CITY OF WACO

Date: 09/25/2020
RFB No: 2020-051
Commodity: Street Improvements – 2019 Reclamation Phase 1
Purchasing Agent: Mr. Kasey Gamblin

Addendum No: 2
Questions and Answers
Changes to Specifications and Drawings
Updated Bid Form

2019 Street Preservation Phase 1 – Contractor Questions (Addendum No.2)

**STREET IMPROVEMENTS
2019 RECLAMATION PHASE 1
RECLAMATION MAP
PARROTT AVE
STA 0+00 TO 3+50**

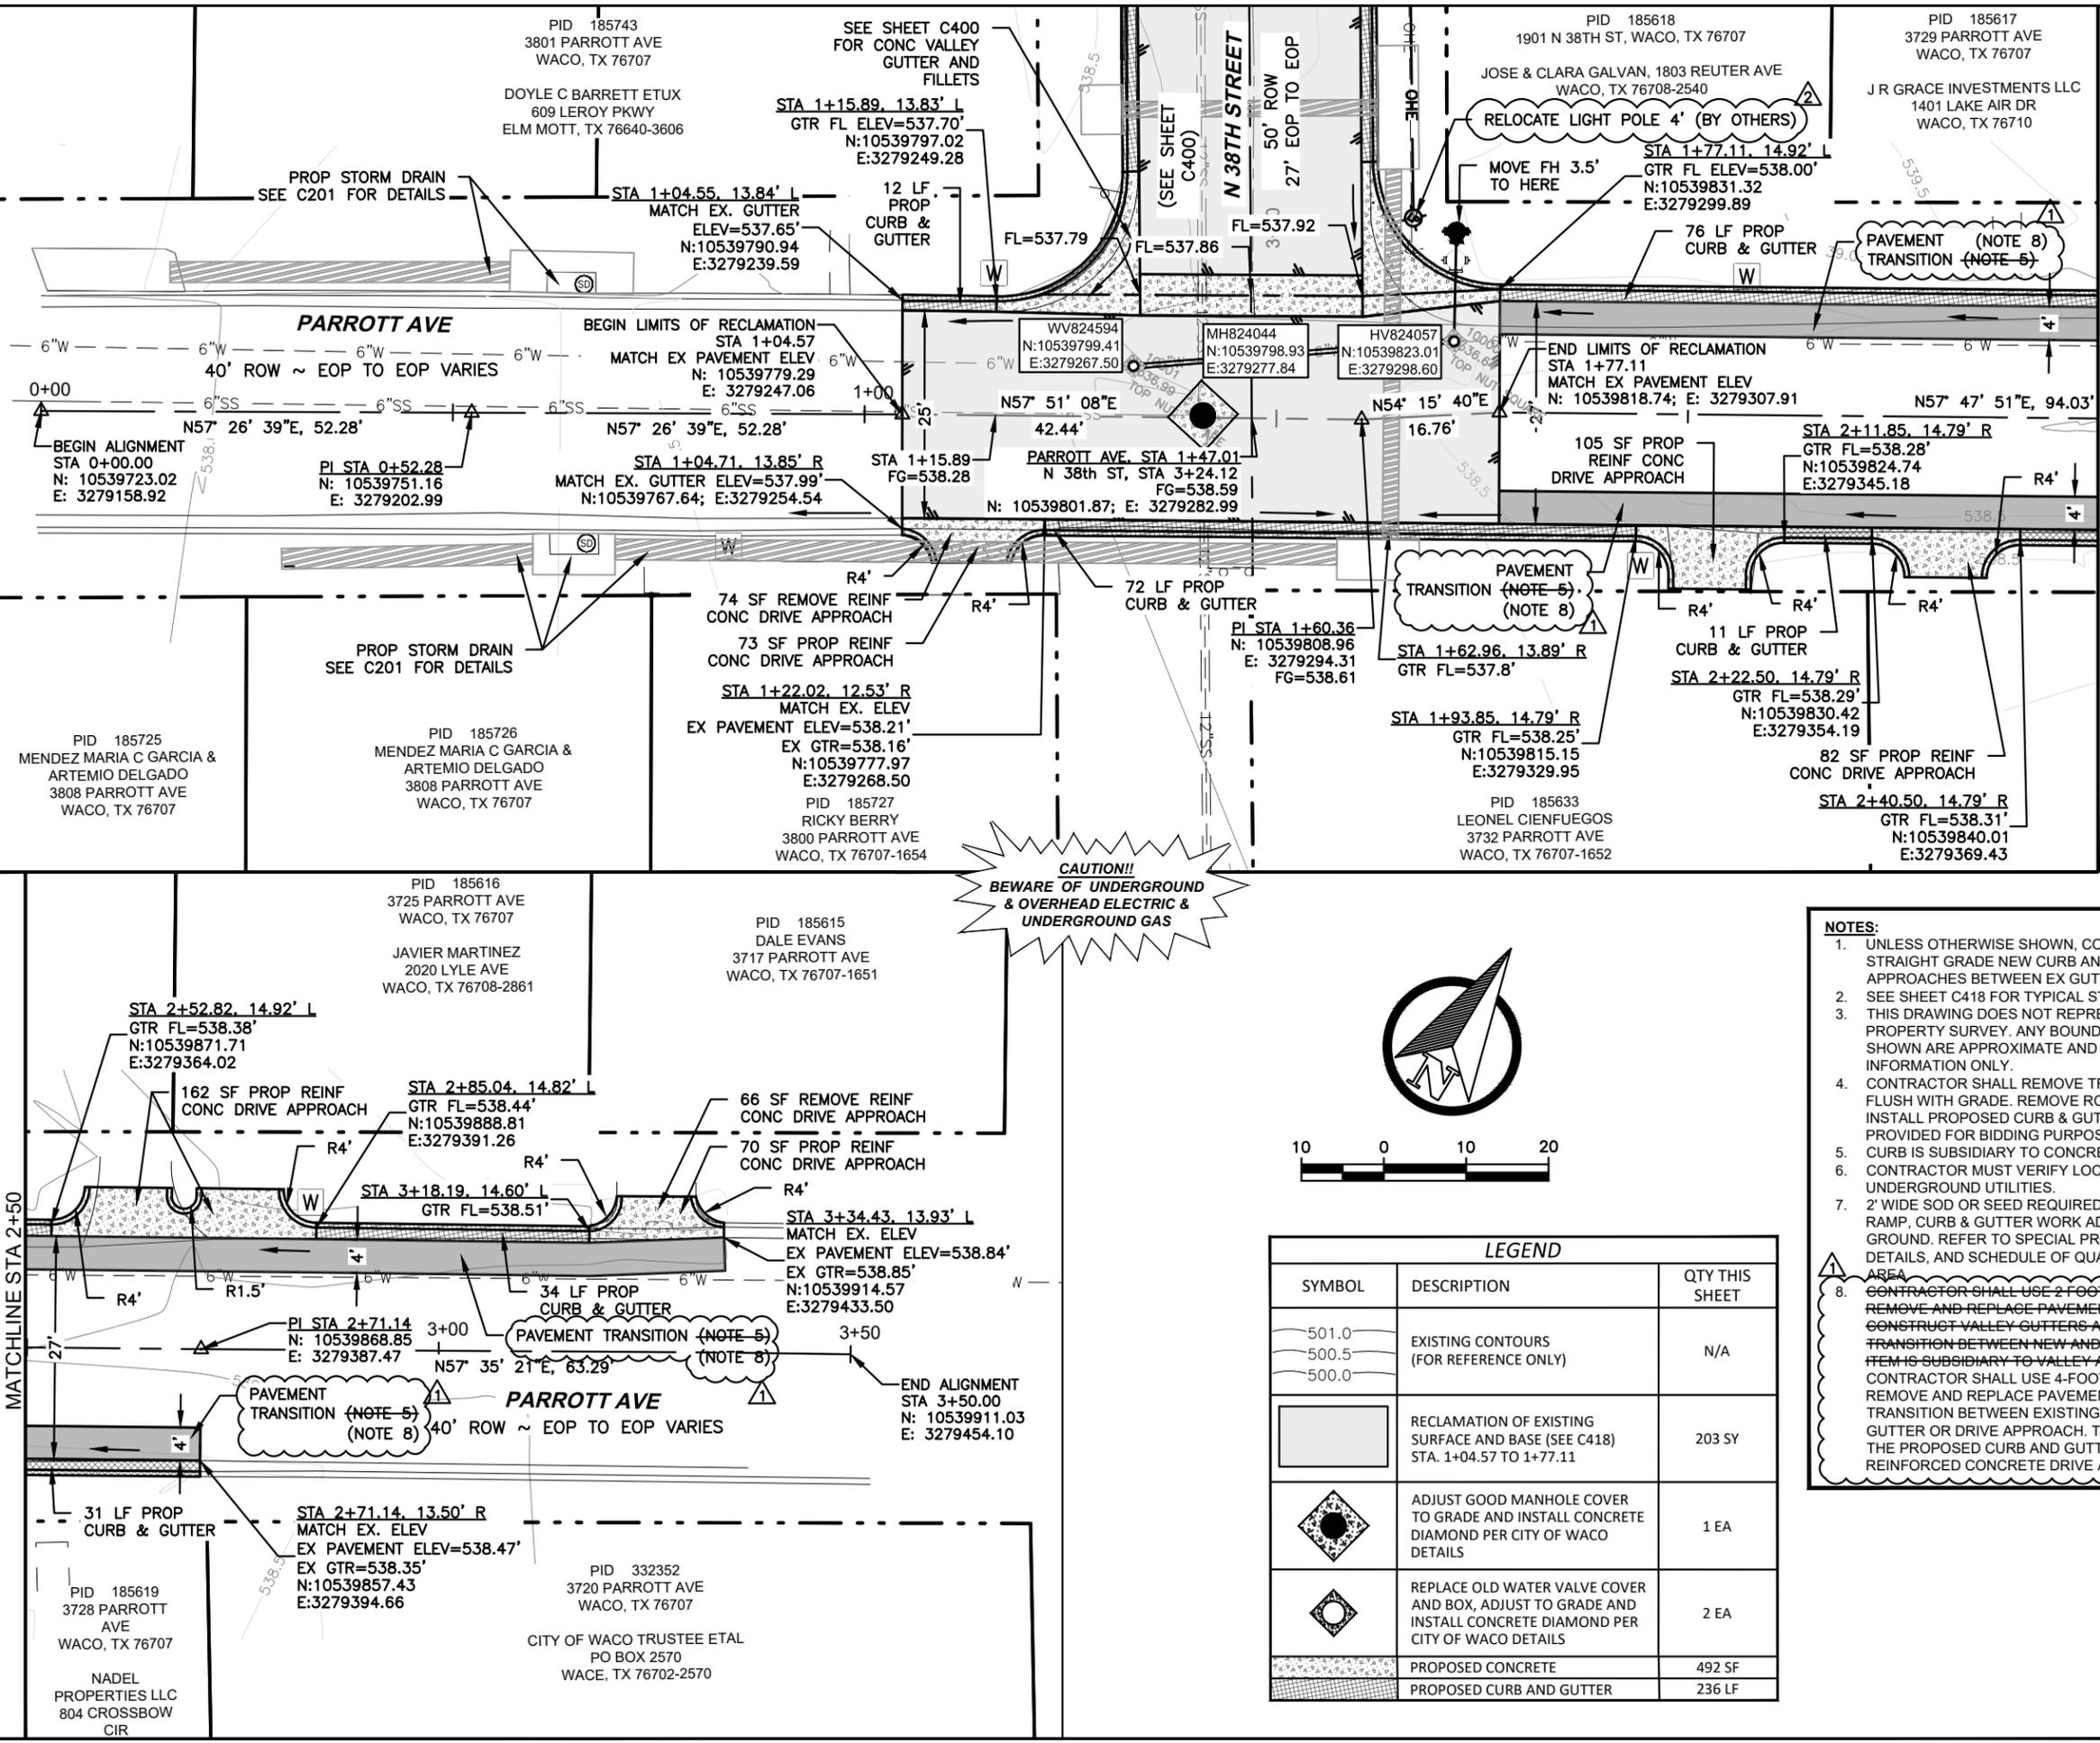
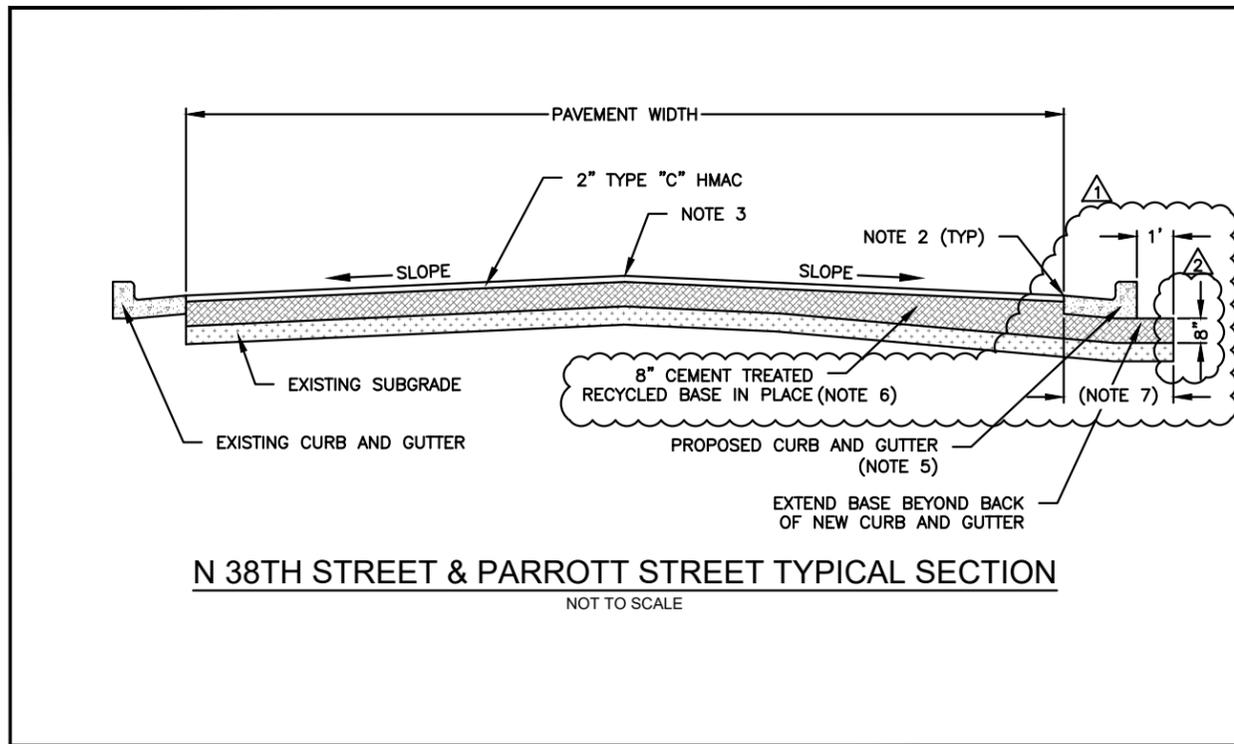
5. There is a light pole shown on Sheet C200 that is designated to be relocated. Who will per this work?
6. Will the City be clearing the trees around the Cherry Street bridge to give access to the bridge bid items?

5. The City will coordinate relocation of the light pole with Oncor. Note on C200 will be revised to clarify.
6. No. The Contractor will be required to clear any trees or vegetation required to access the Cherry Street Bridge work items. Section 1.14 of the Special Project Provisions has been revised to clarify.

**STREET IMPROVEMENTS
2019 RECLAMATION PHASE 1
TYPICAL STREET SECTIONS**

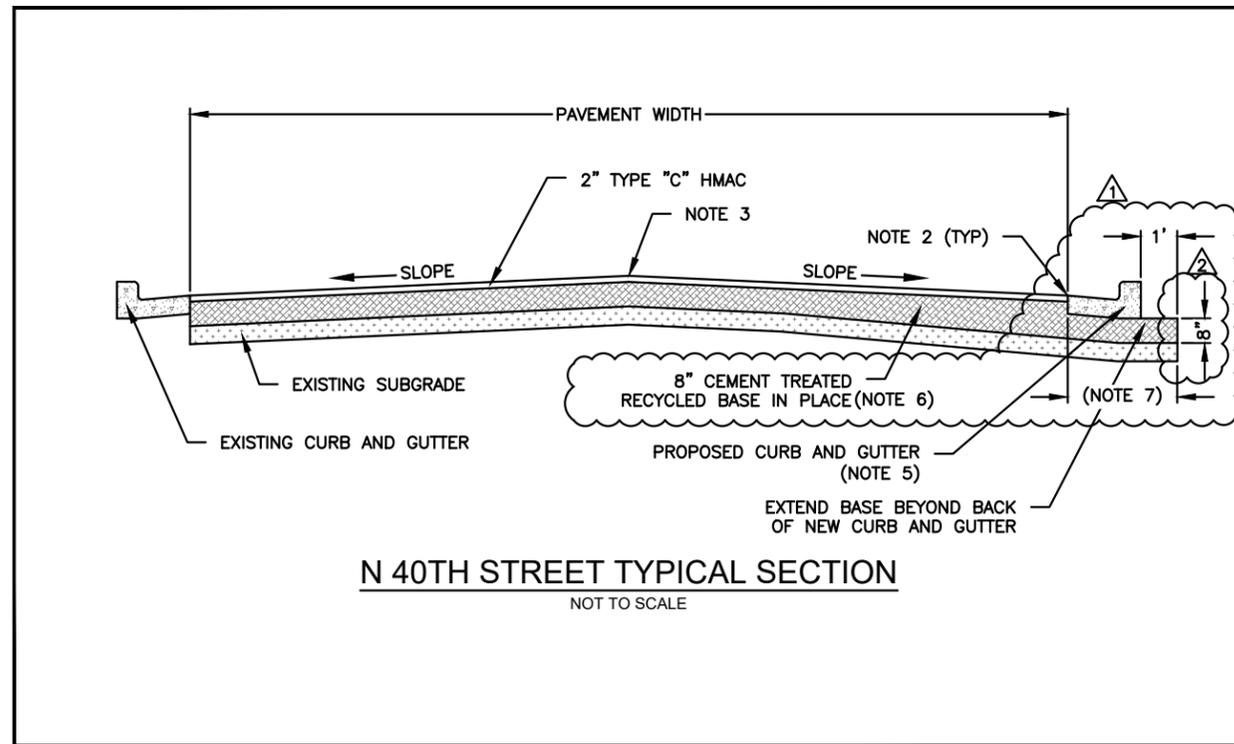
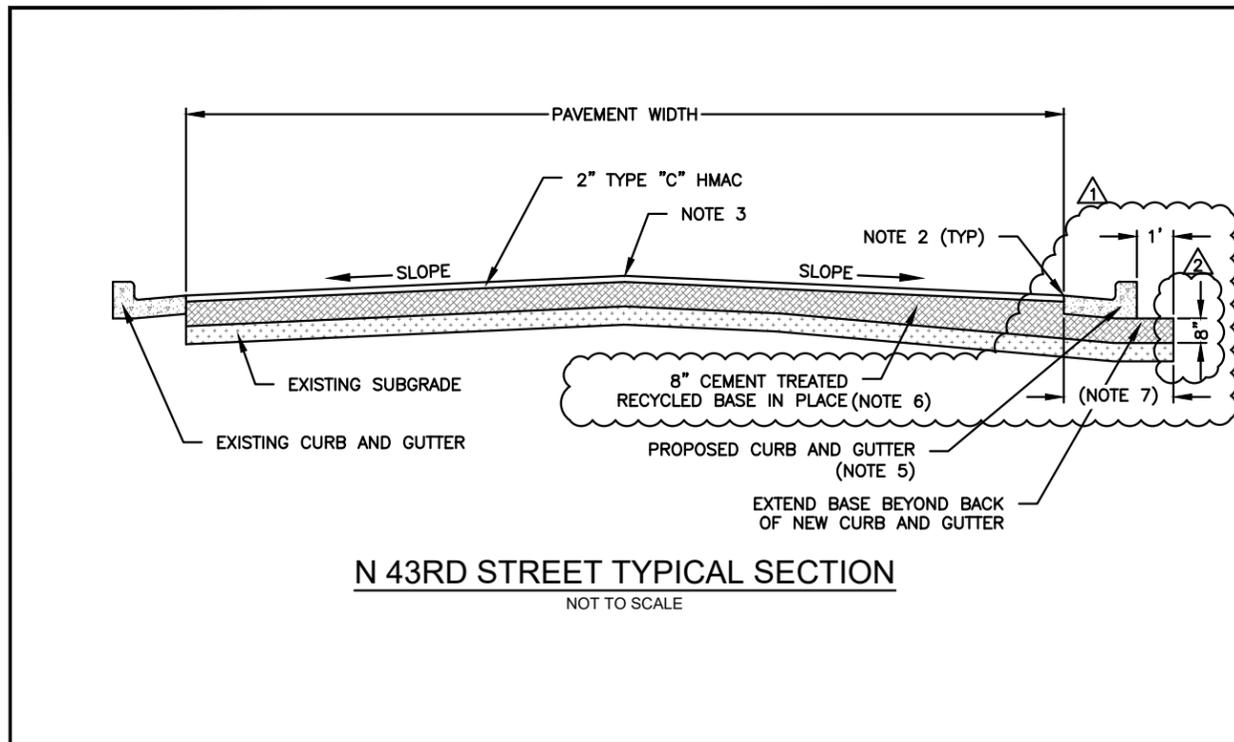
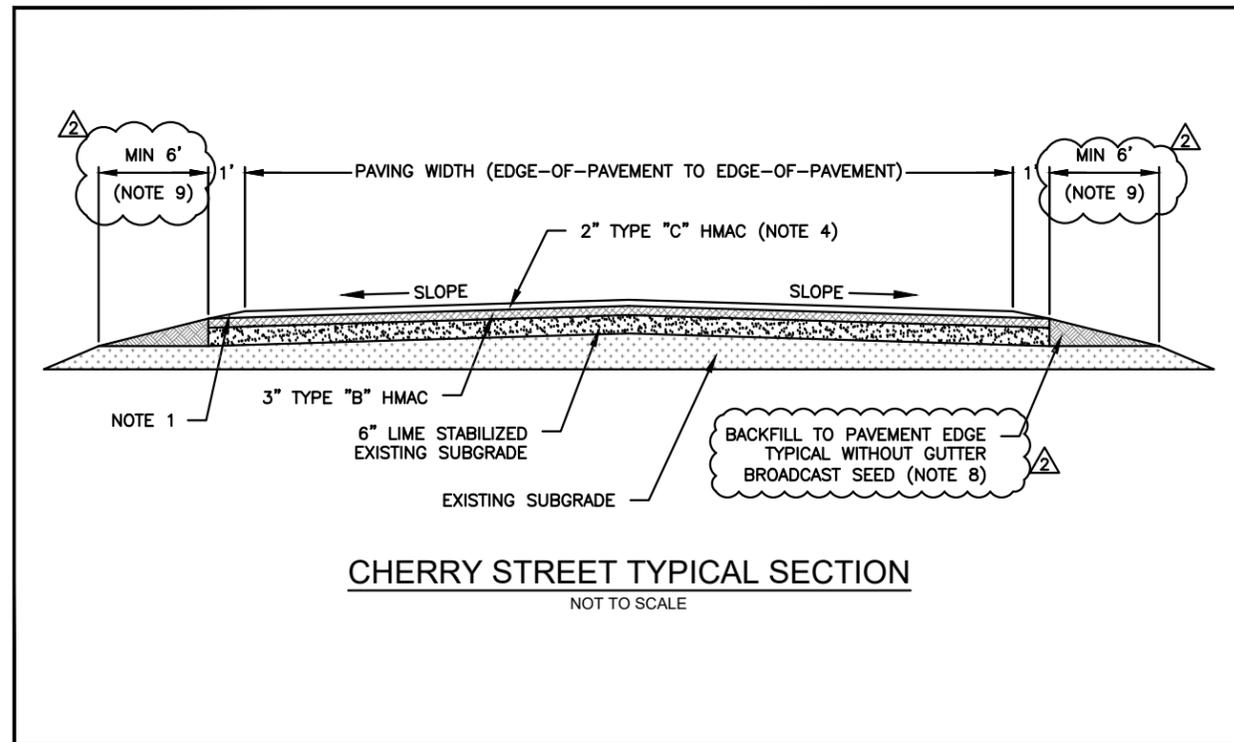
1. Following up to the response to Question 1 on Addendum 1:
 - a. As I understand the response, we are to cement treat whatever depth of existing material is available on the street, then add plant mix cement treated base on top of this to achieve 8" where the existing pavement depth is not 8"? Is this correct?

- b. If we are cement treating the existing roadway, and we add material on top of this to achieve 8" where it is less than this, it would appear that we are changing the cross slope of the roadway. Is this correct?

- c. If the existing cross slopes and elevations are supposed to remain unchanged, then in order to achieve the 8" depth where the road is not 8" would require removing and stockpiling the existing road base, cutting the subgrade to the depth needed to have 8" of cement treated base, then replacing and cement treating the base. Please clarify that this is not the intent.

- b. This is not correct. See Notes 3 and 4 on Sheet C418. In general, for N 38th St., N 40th St., and N 43rd St., the proposed pavement surface elevations shall match the existing pavement elevations (i.e., no change in cross slope). For Cherry St., the proposed pavement surface elevations is (in general) 2" above the existing pavement elevations.

- c. The procedure as described in the question is correct. In order to provide a new pavement section with 8" of cement treated base and 2" of TY C HMAC, the Contractor will need to remove and stockpile/windrow the existing road base and remove enough subgrade so that the finished pavement surface elevations match the existing pavement surface elevations. As noted in Section 15.12 of the Special Project Provisions (Sheet C007), "Any haul off required to meet grade in plans shall be taken from subgrade material."

6. IMPORTED GRAVEL BASE COURSE WILL BE REQUIRED IN ADDITION TO THE CEMENT TREATED RECYCLE BASE IN PLACE TO PROVIDE AN 8-INCH THICKNESS. SEE SPECIAL PROJECT PROVISIONS FOR ADDITIONAL REQUIREMENTS.

Project No: 18ST2003C	Sheet No. C419
Issue Date: AUGUST 2020

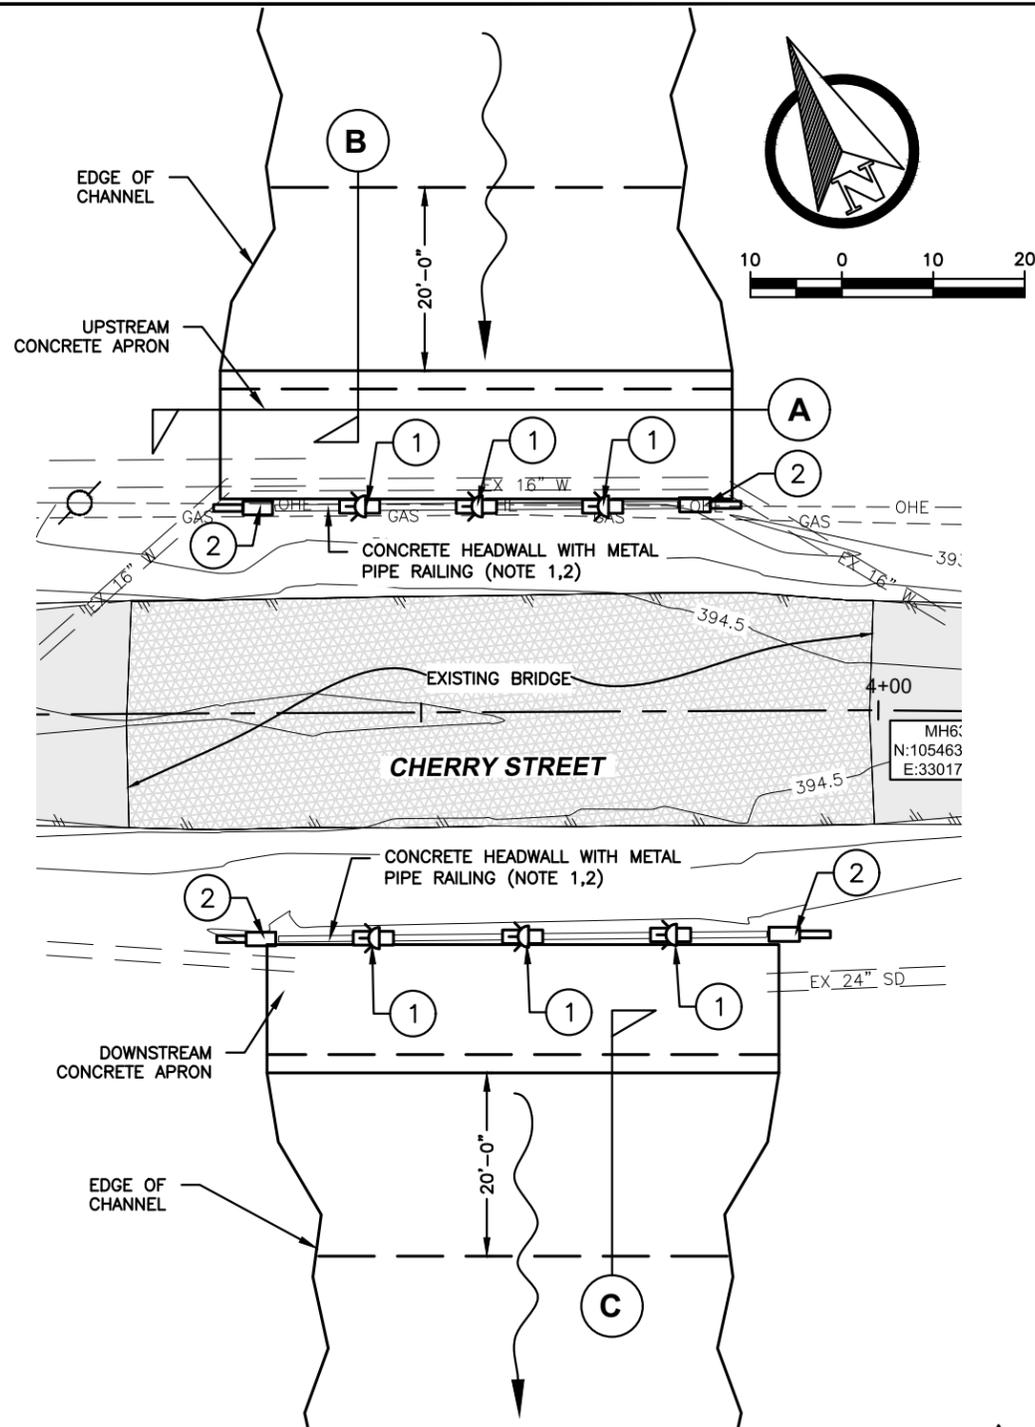
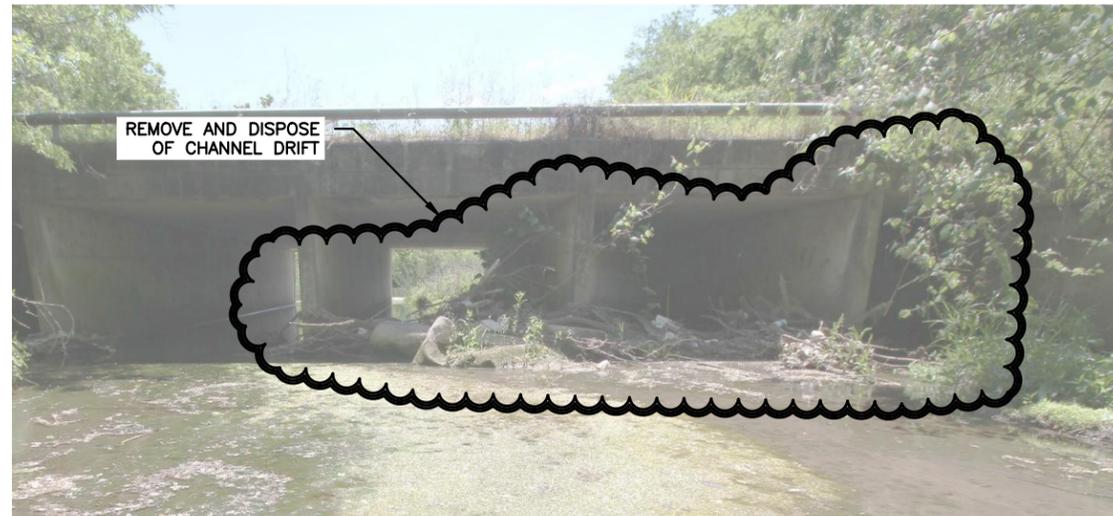
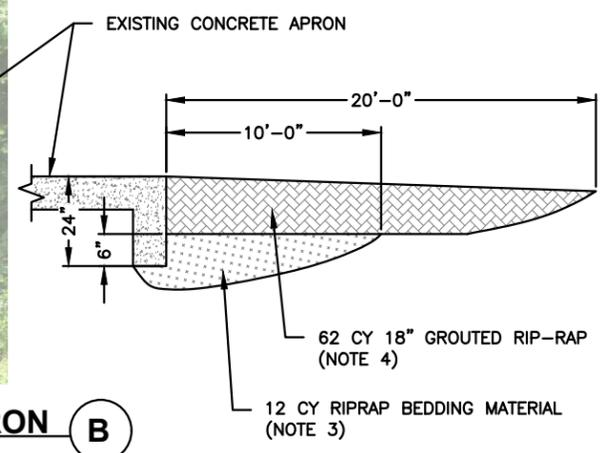
9. The rail on the Cherry street bridge appears to be galvanized and in good shape. Painting this rail is likely to be very expensive. Is the paint necessary?

8. The section shall be 2" of TYP C HMAC over 8" of 2000 psi concrete. Details on C801 and C802 have been revised.
9. Upon further investigation, the rail will not need to be painted. Sheets C005, C008, and C419 have been revised.
